**CLARKE COUNTY PLANNING COMMISSION
TABLE OF CONTENTS
April 6, 2018 Business Meeting**

MAJOR SUBDIVISION (S-17-01)

Coquette Estates Subdivision

**RE: Coquette Estates
Road Construction Plan**

CS8003
 SHEET 4 OF 6

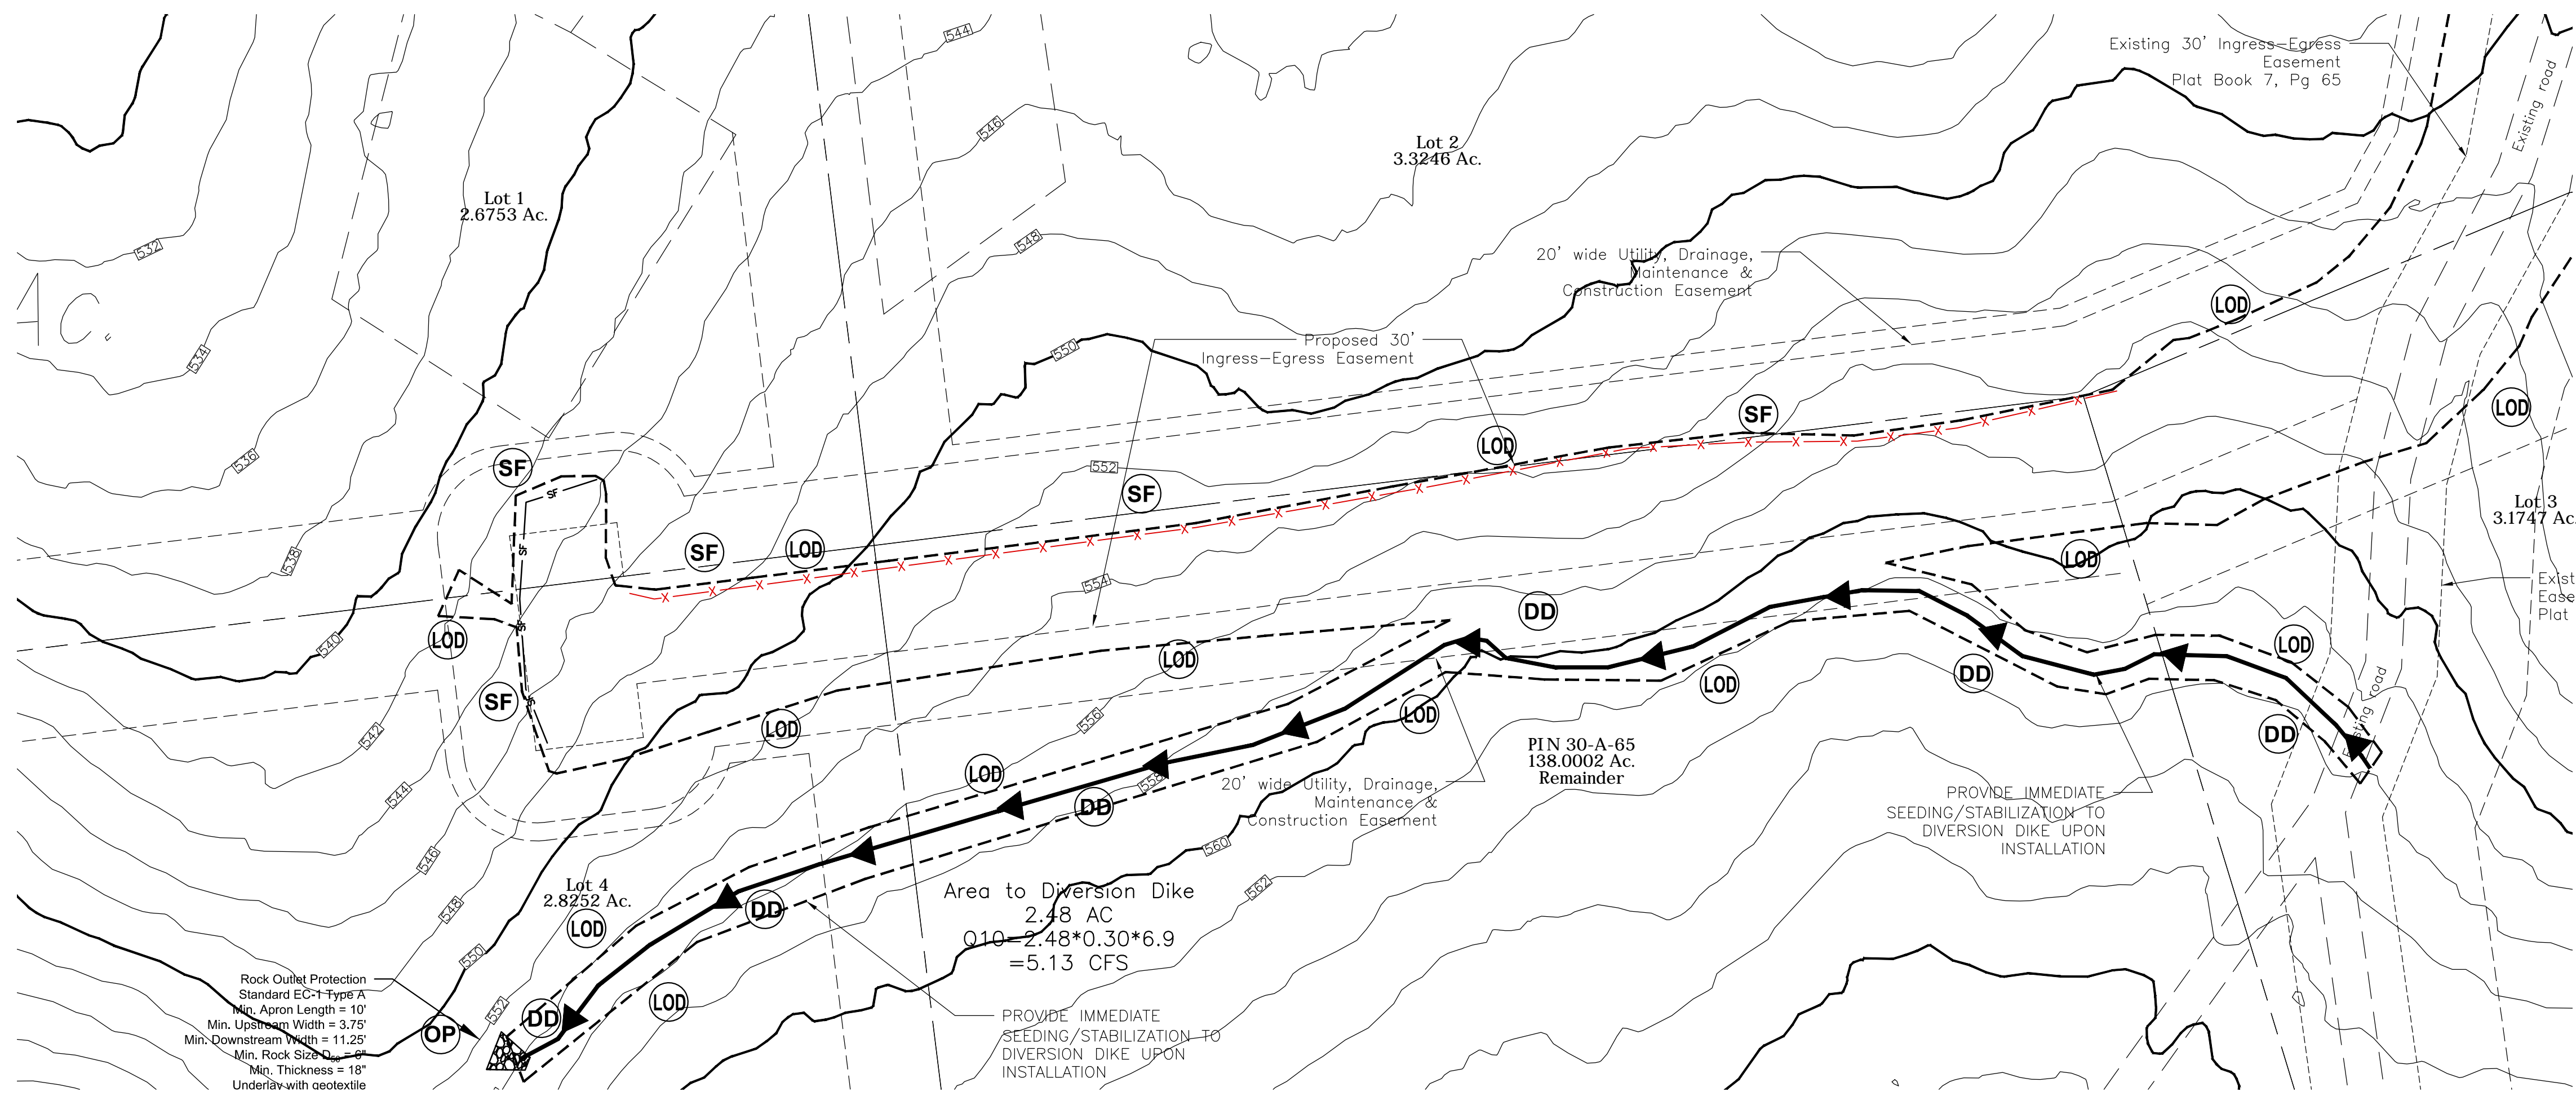
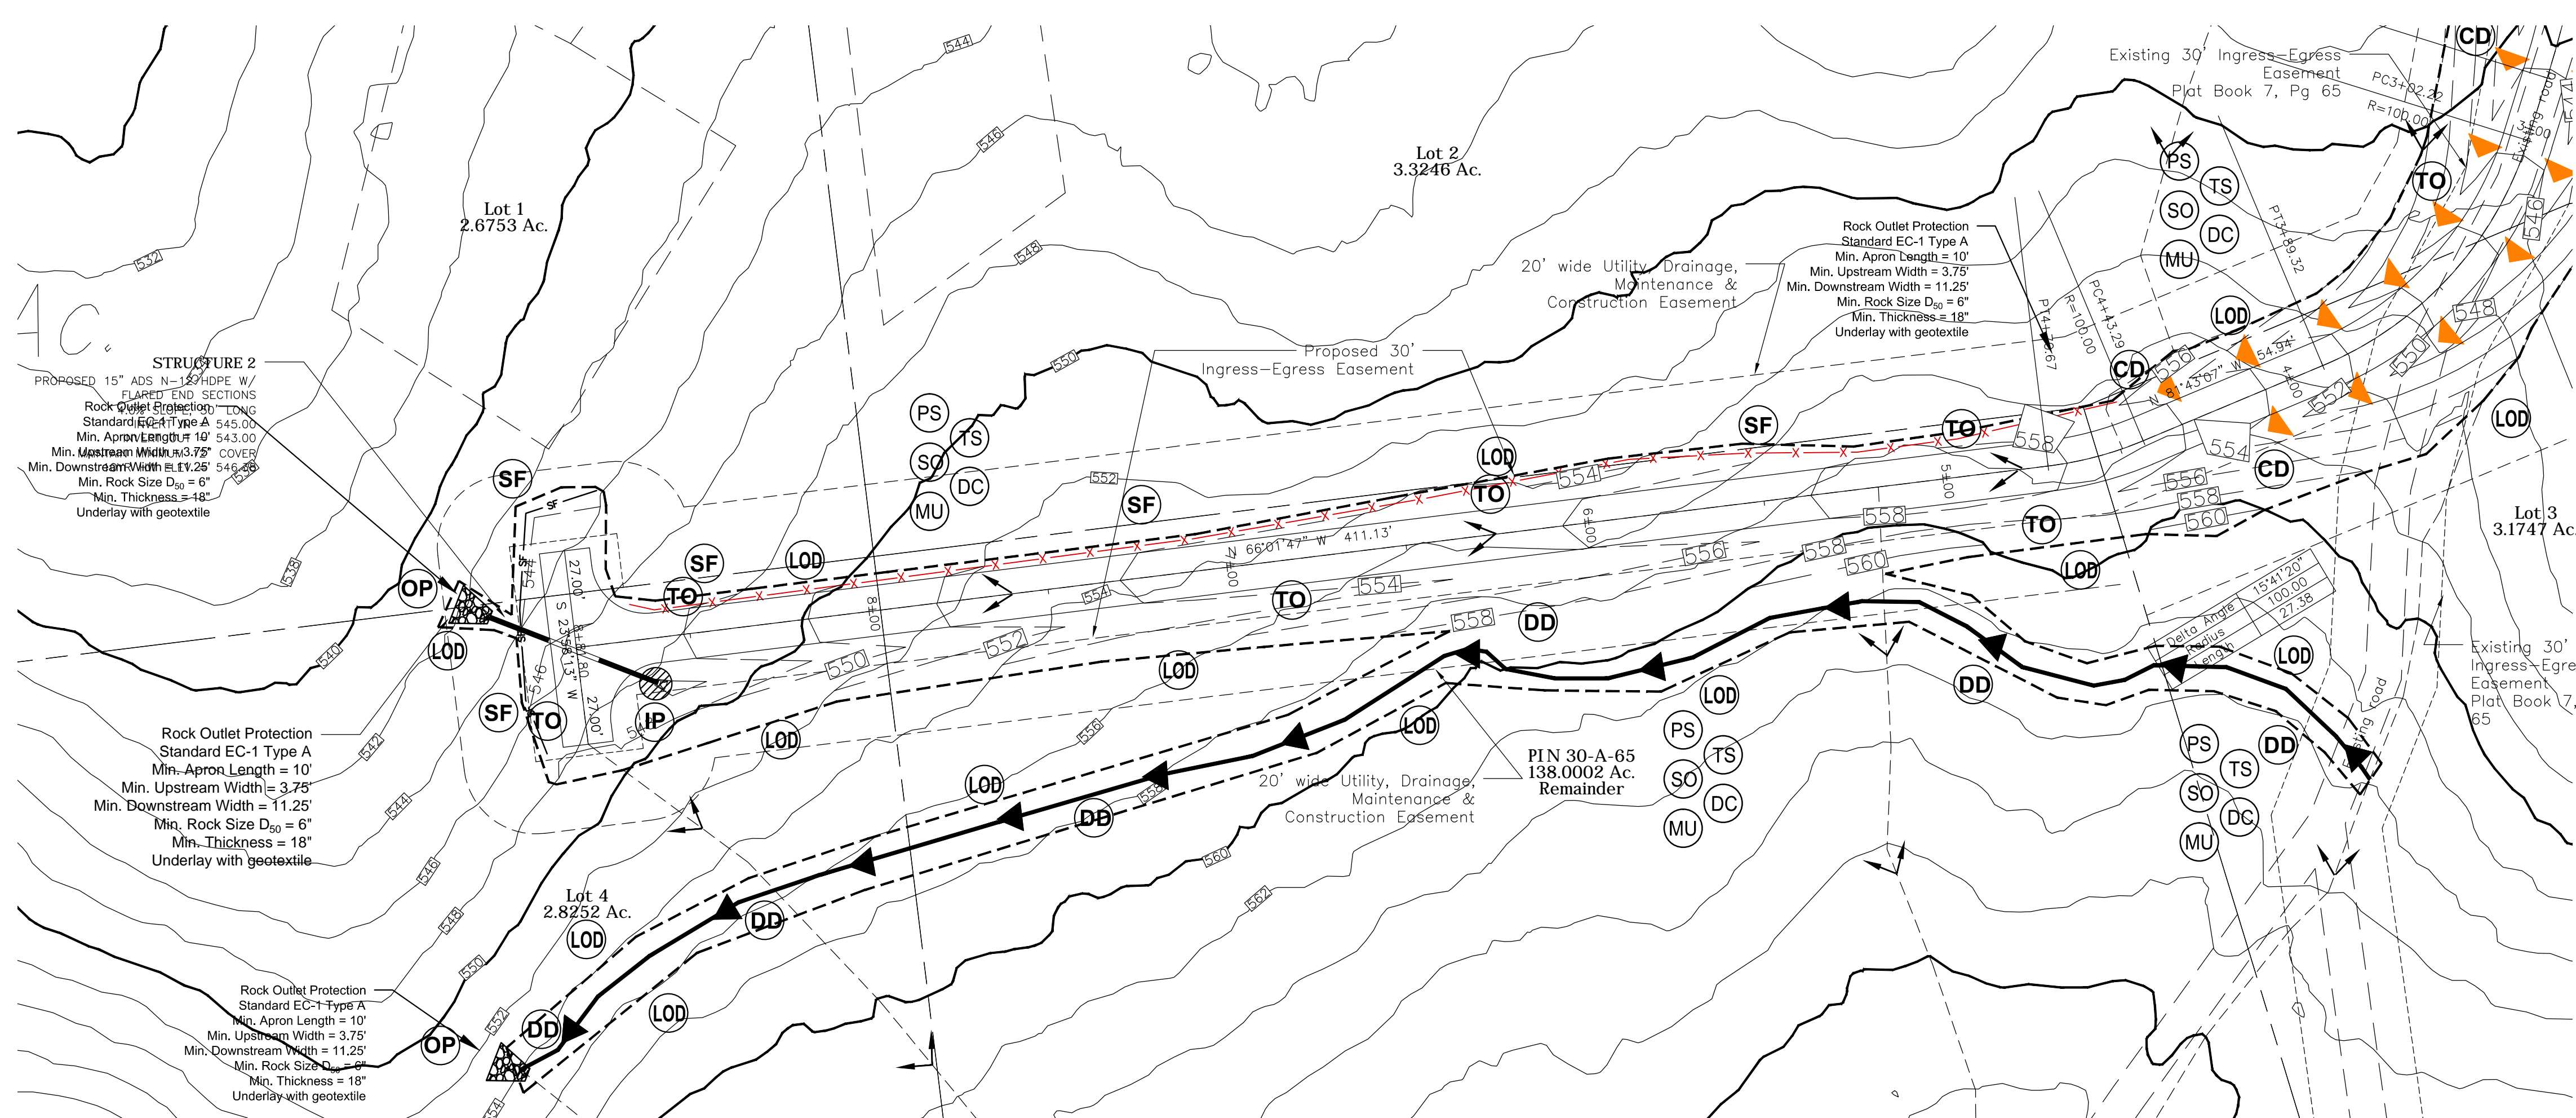
13. Comment: EC-3 matting is shown on Sheet CS8003 in the north side ditchline from Station 0+40 to Station 2+00. We are uncertain if this is a special design for the EC-3, since Note 4 on Plan Sheet CS1000 indicates that EC-3 is required in all ditches exceeding 4% slope. If EC-3 is to be called out graphically, it should be called out in all required locations.

Response: Note 4 on Plan Sheet CS1000 has been removed.
